Addendum No. 2

Project: **2018 Interior Renovations**
 Jeffersonville Township Public Library
 Jeffersonville Facility
 Jeffersonville, Indiana

Project No.: 1723.01

Date: April 19, 2018

Sheet
AD-2a

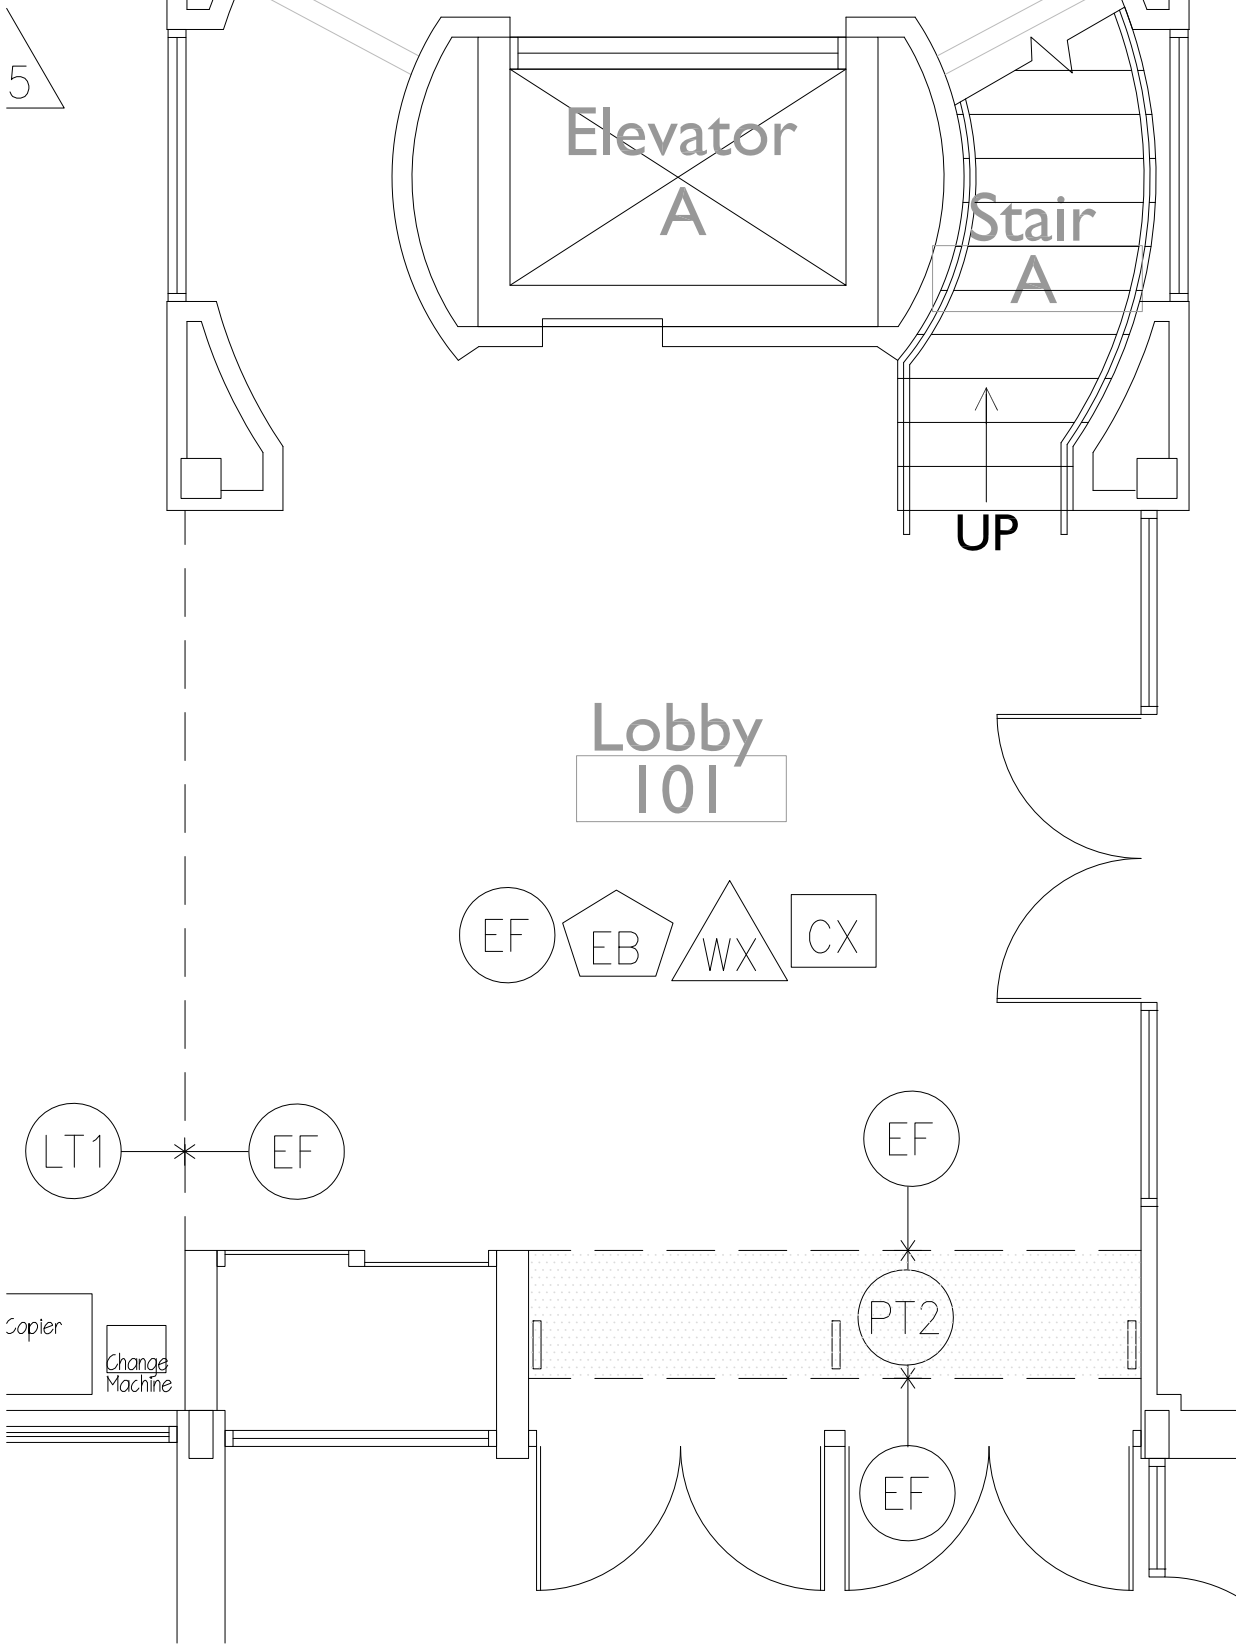
Add Keynote D27 in Lobby between Vestibule and Elevator A relating to electrical work for security gates. Refer to attached drawing AD-2a for layout. Remove full tiles as required at grout lines, do not cut through individual tiles.

Add Keynote PT2 in Lobby between Vestibule and Elevator A. Refer to attached Drawing AD-2a for layout.
